Our reference: ECM Ref: 9772045
Contact: Kathryn Saunders
Telephone: (02) 4732 8567

**Request for Advice - EIS - Access Logistics Park SSD-17647189 at No. 884
– 928 Mamre Road Kemps Creek**

Image 1: Excerpt from EIS, Figure 11 – Masterplan / Benching Plan – Stage 2 (p.25)

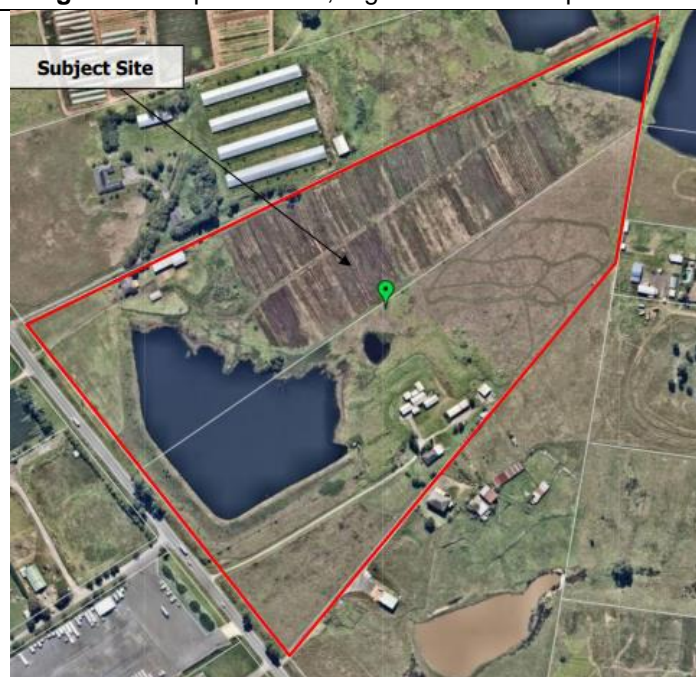
The orientation of the large warehouse proposed on Lot 2 (refer **Image 1**) is such that its longest and unarticulated elevation presents as one continuous bulky wall to Mamre Road, close to a proposed main Precinct entry intersection. The office location near the intersection is supported, although greater canopy tree planting and layering of landscaping is encouraged.

Council recommends that a far greater landscaped setback, inclusive of mounding be provided to Mamre Road as this warehouse will present poorly to the street with limited and ineffective landscaping proposed – which will be further eroded when Mamre Road is widened (as is planned) and owing to the proposal into locate deep on-site detention in this front setback surrounded by retaining walls (which is not supported by Council as detailed further below).

Image 3: Excerpt from Architectural plans – Section 1 Mamre Road

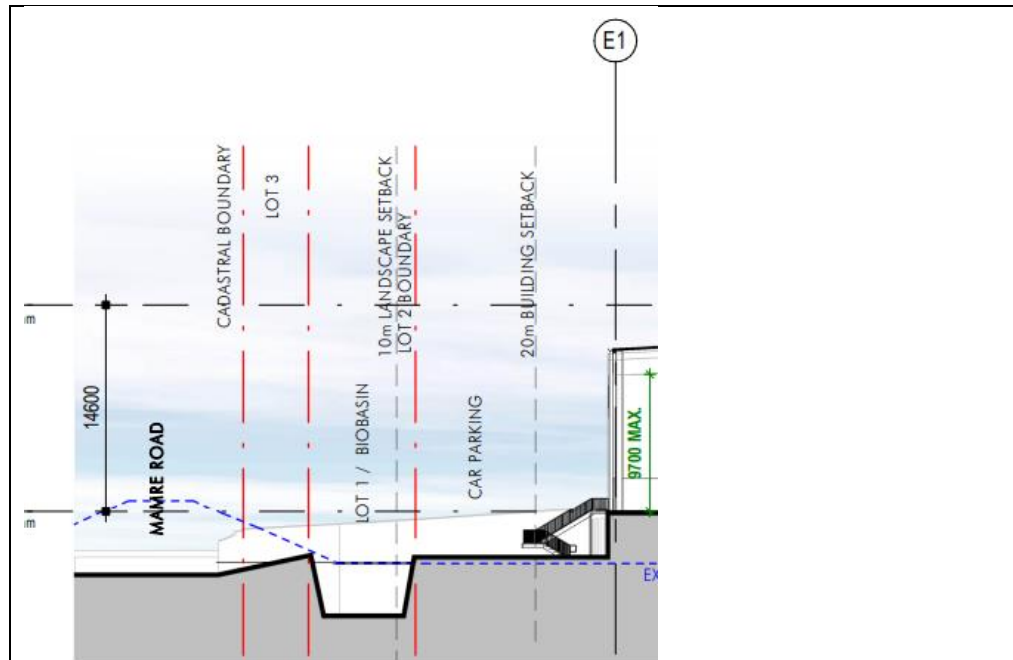
DPIE is strongly encouraged to require that the applicant suitably resolve the traffic, stormwater, water quality, levels and landscape issues raised. It is recommended that the applicant clearly indicate the ultimate of final Mamre Road (widened) alignment on all affected plans and sections (including on Section 1 - refer **Image 3** below). Documents are to detail the interim and ultimate/final roadway designs.

Council raises for the Department's consideration that the proposal is considered inadequate in its engineering design, water quality and landscape outcomes, such that in its current state the design will not be sustainable, and result in detrimental impacts in neighbouring sites and on the quality and presentation of the development within the Precinct (refer **Images 3 & 4** below).

Image 4: Excerpt from Architectural plans – Section 1 26m (26.4m) wide Access Road between Lots 15 & 16

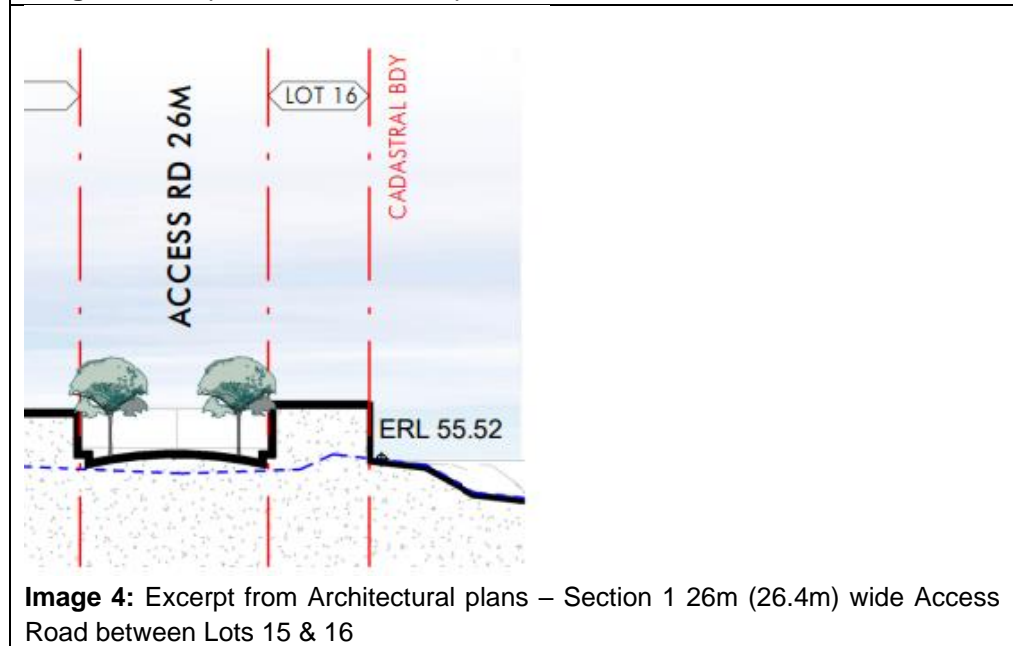
Sections indicate that Estate roads are proposed in deep areas of cut with high retaining walls hard up against the roadway boundary (example refer **Image 4** above). In relation to the levels proposed at image 4, it is not understood why Lot 16 is filled when natural ground level is consistent with the roadway.

DPIE is advised that Council will reject dedication of local roads proposed in this arrangement owing to asset management implications, safety and amenity reasons.

The Draft DCP includes that level transitions are to be managed between lots and not interface the public domain. In accordance with section 4.4.1 of the Draft DCP, finished ground levels adjacent to the public domain or public road dedication, be no greater than 1.0m above the finished road level (or public domain level).

The Draft DCP includes that where a level difference must exceed 1m the landscaping and retaining walls are to be stepped back within the private lot and also required that walls up to 3m in height are to be setback 2m into the property boundary.
